Unusual noise while driving from sealing ring

REF NO: TJ 33524.2.0	ISSUING DEPARTMENT: Technical Service	CAR MARKET: United States and Canada		
3 US 7	PARTNER: '510 Volvo Car USA	ISSUE DATE: 2020-03-25	STATUS DATE: 2020-04-02	
FUNC GROUP: 7731	FUNC DESC: Hub, front	Page	1 of 3

Technical Journal 33524.2.0

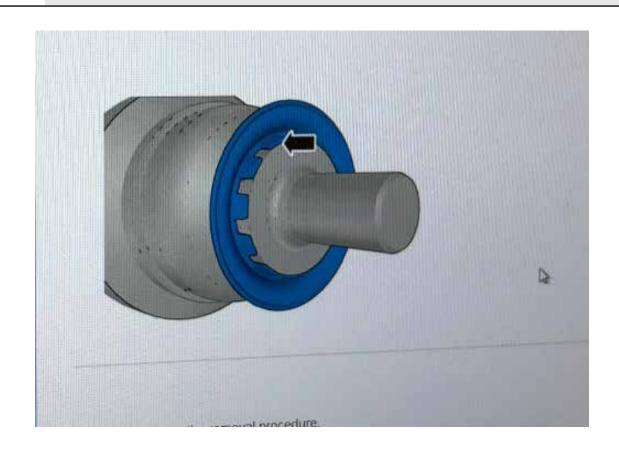
If customer experiences unusual noise from front drive shaft, please follow advice under Service.

If noise is confirmed, check first if the sealing ring is displaced, if so, proceed with replacement of the sealing ring according to VIDA.
